Appl. No. 10/767,599  
Amdt. dated Apr 18, 2005  
Reply to Office action of Mar 24, 2005

**Amendments to the Drawings:**

### **REMARKS/ARGUMENTS**

FIG 2

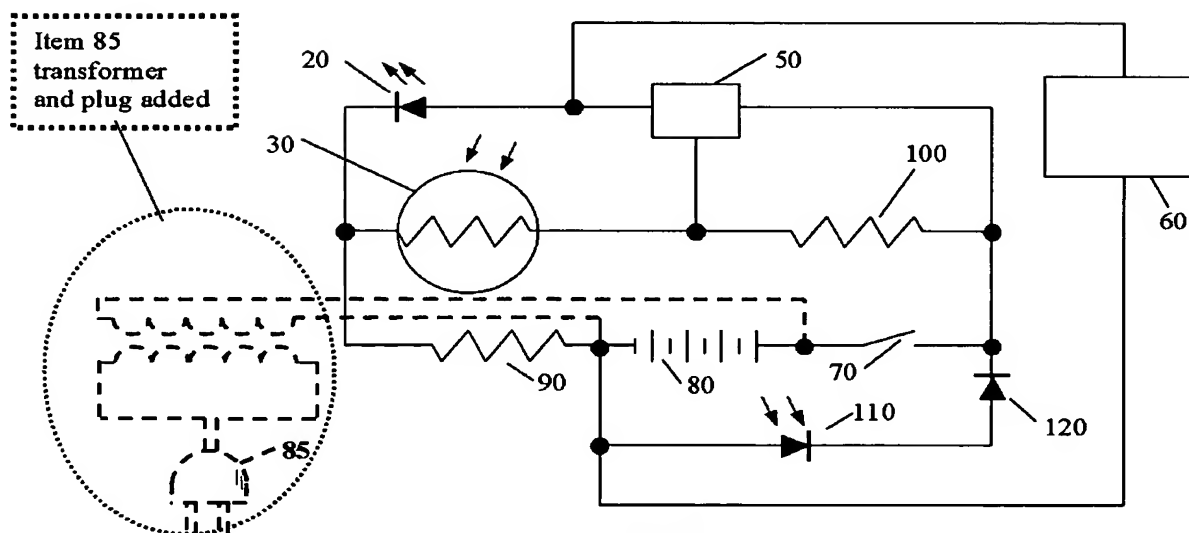
The attached sheet of drawings includes changes to Fig. 2. This sheet, which includes Fig. 1-2, replaces the original sheet including Fig. 1-2. In Figure 2, item 85 all outlet plug has been added.

Figure 2 was modified to show the external power plug. This was performed by including item 85 in the figure and was supported in the claims.
